US DEPARTMENT OF ENERGY
HANFORD WASTE VITRIFICATION PLANT

DESIGN CHANGE NOTICE

DCN - 0100 | REV 1 | PAGE 1 OF 18

DCN TITLE: THIS DCN-0100 SUPERSEDES "DCN-0096" & "DCN-0096 REV 1"

DETAIL J / 119279

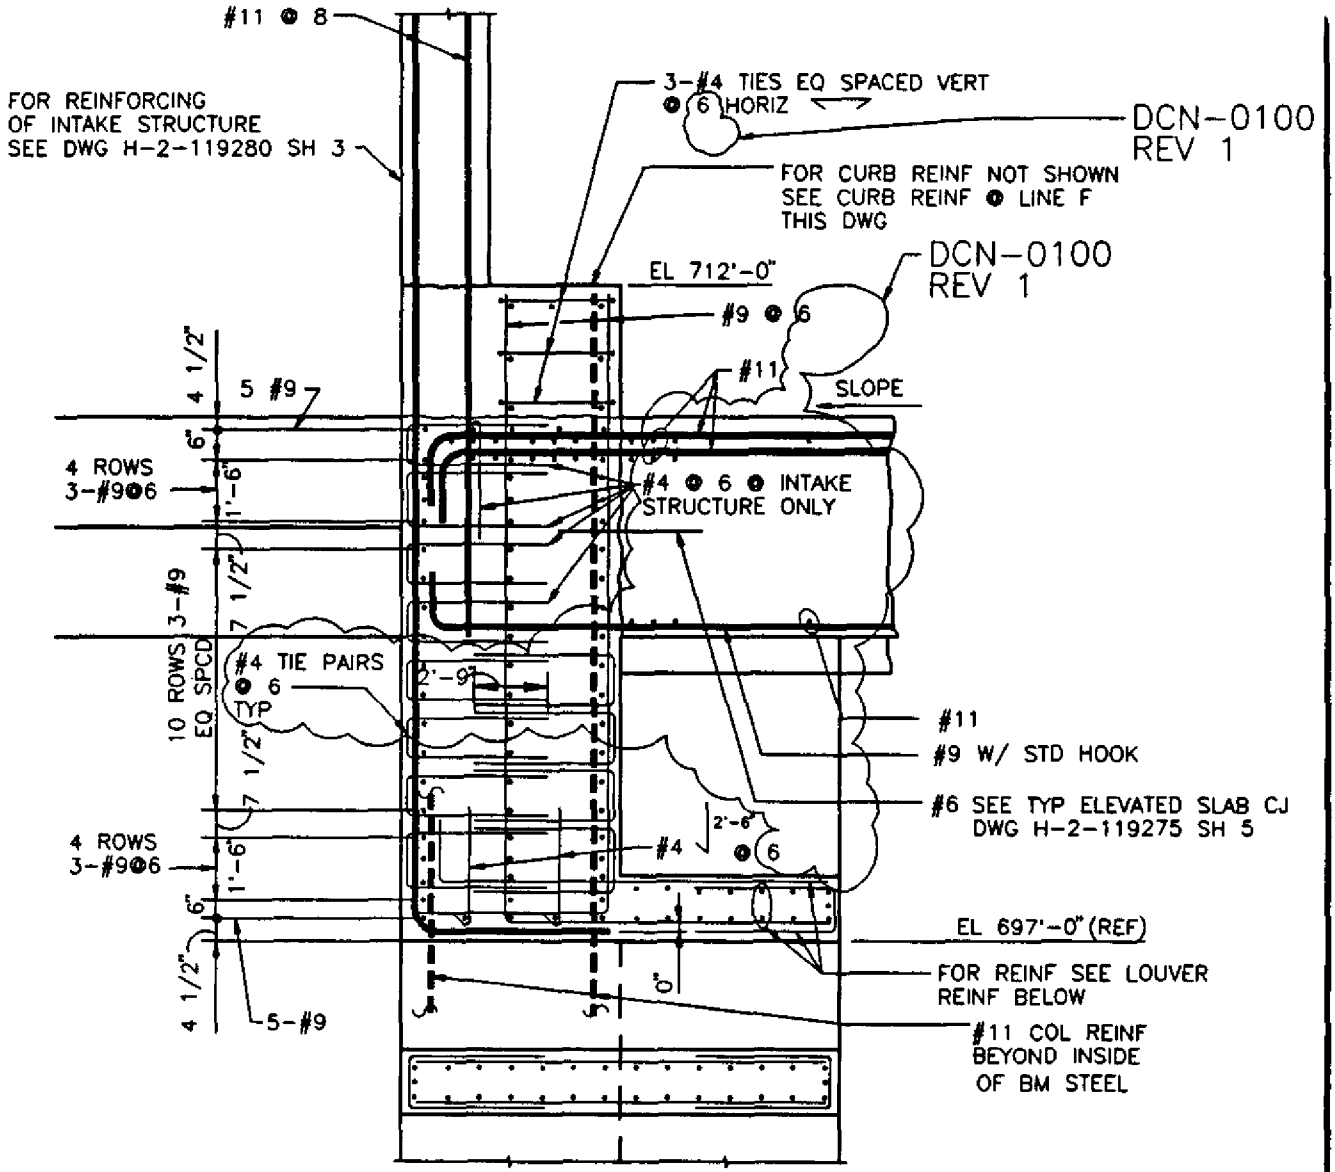
FLUOR DANIEL	U.S. DEPARTMENT OF ENERGY HANFORD WASTE VITRIFICATION PLANT	DESIGN CHANGE NOTICE
DESCRIPTION OF CHANGE: REMOVE HOLD HWVP-FD-364. REVISE REINFORCING SPACING AND TIE LAP DIMENSION		BASE DOC. NO. H-2-119285 SHT/PG. 1 REV. 2 CR NO. CR-HWVP-1025 DISCIPLINE: STRUCTURAL/DCN0096E
PREPARED BY: Amanda Tillman	DATE: 9/28/93	DCN - 0100 / REV. 1 / PAGE 16
DISCIPLINE ENGINEER:	DATE: 9/28/93

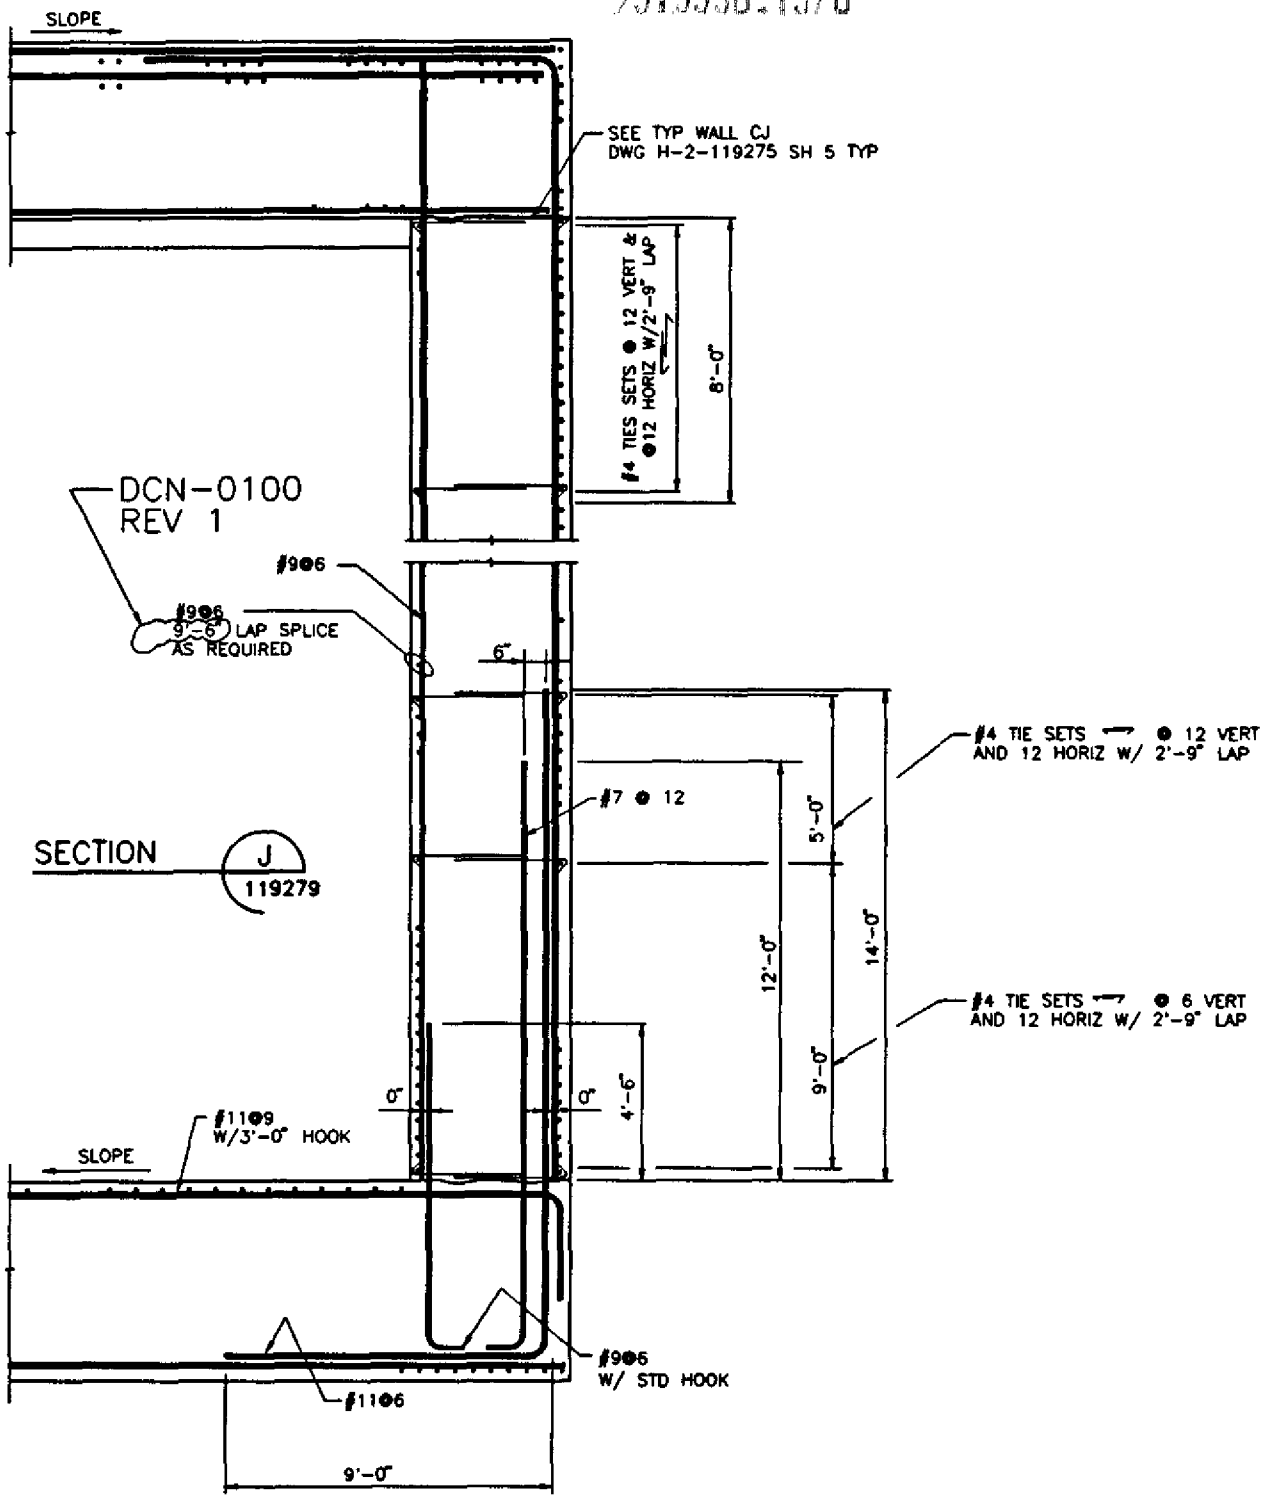
FLUOR DANIEL	U.S. DEPARTMENT OF ENERGY HANFORD WASTE VITRIFICATION PLANT	DESIGN CHANGE NOTICE
DESCRIPTION OF CHANGE: REVISE LAP SPLICE		BASE DOC. NO. H-2-119285 SHT/PG. 1 REV. 2 CR NO. CR-HWVP-1025 DISCIPLINE: STRUCTURAL/DCN0096L
PREPARED BY: Armando Villegas	DATE: 9/28/93	DCN - 0100 REV. 1 PAGE 17
DISCIPLINE ENGINEER: Robert A. Smith	DATE: 9/28/93

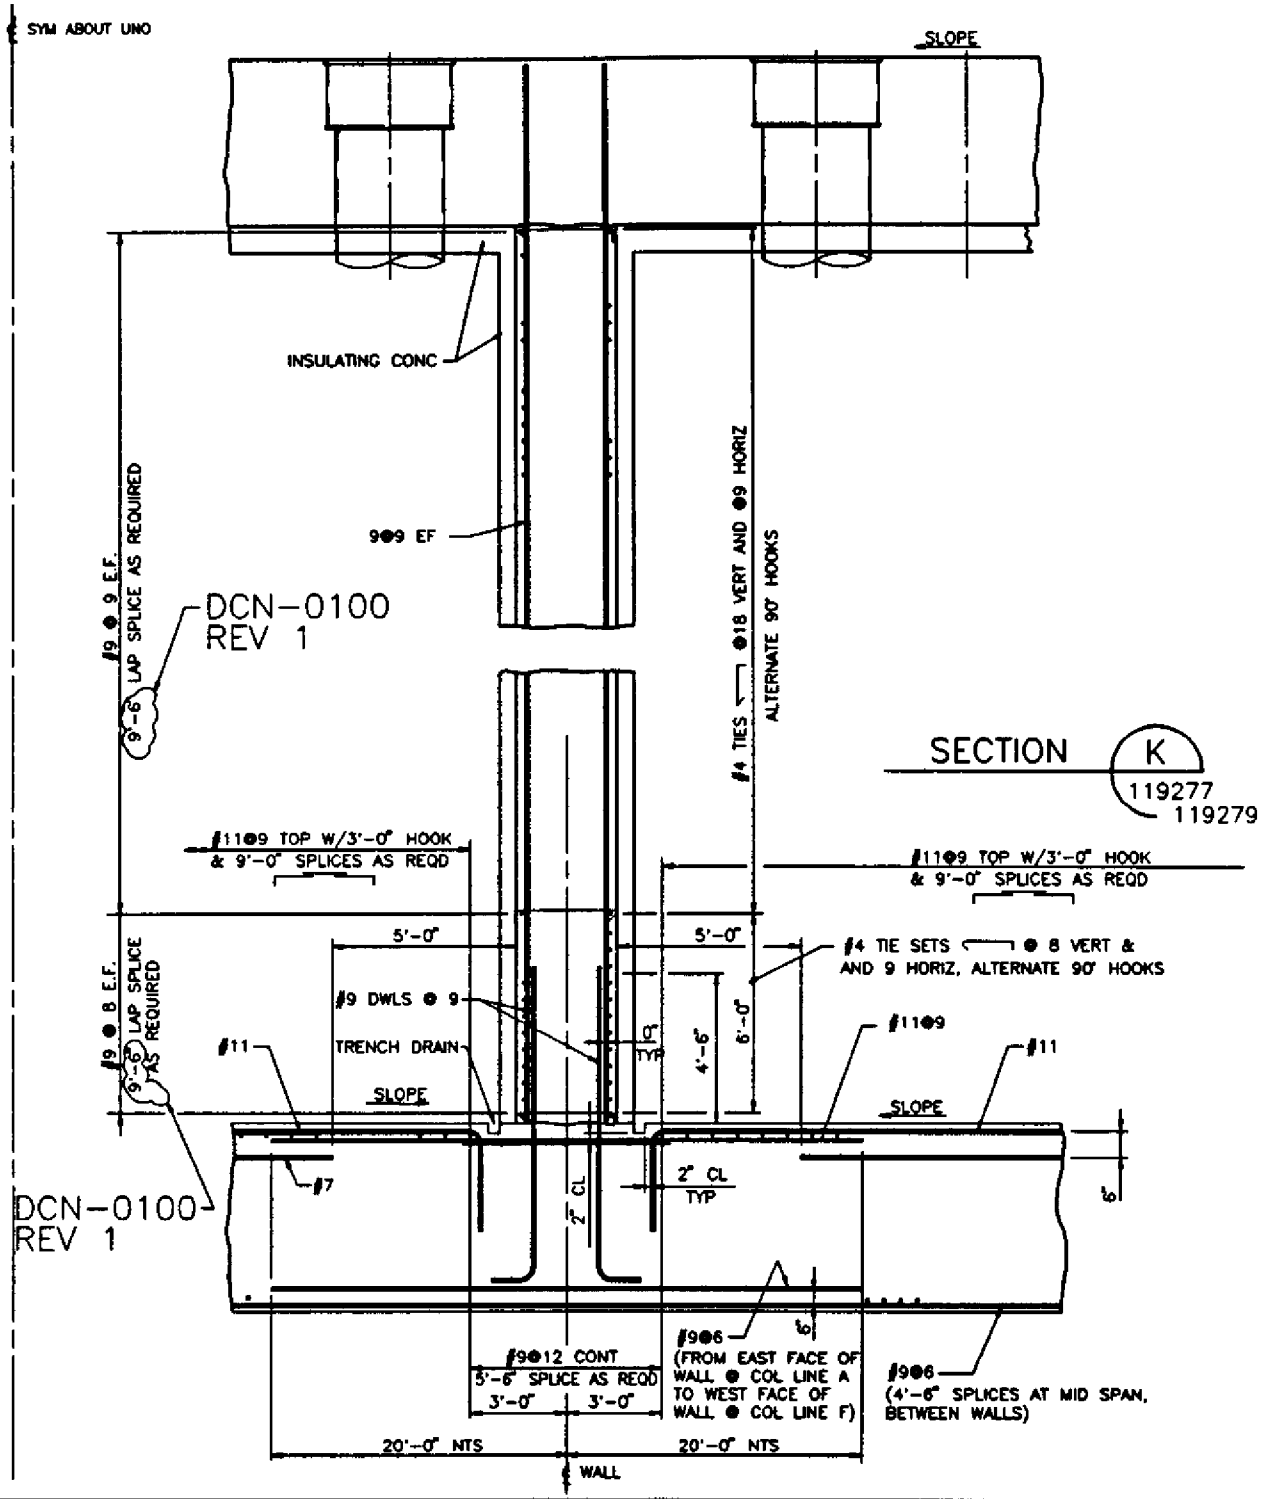
H-2-119286	1	2	CSB VAULT REINF CROSS SECT K	Y	REVISE LAP SPLICE SEE PAGE 18.

FLUOR DANIEL	U.S. DEPARTMENT OF ENERGY HANFORD WASTE VITRIFICATION PLANT	DESIGN CHANGE NOTICE
DESCRIPTION OF CHANGE: REVISE LAP SPLICE		BASE DOC. NO. H-2-119286 SHT/PG. 1 REV. 2 CR NO. CR-HWVP-1025 DISCIPLINE: STRUCTURAL/DCN0081F
PREPARED BY: Armando Villegas	DATE: 9/28/93	DCN - 0100 REV. 1 PAGE 18
DISCIPLINE ENGINEER: [signature]	DATE: 9-28-93
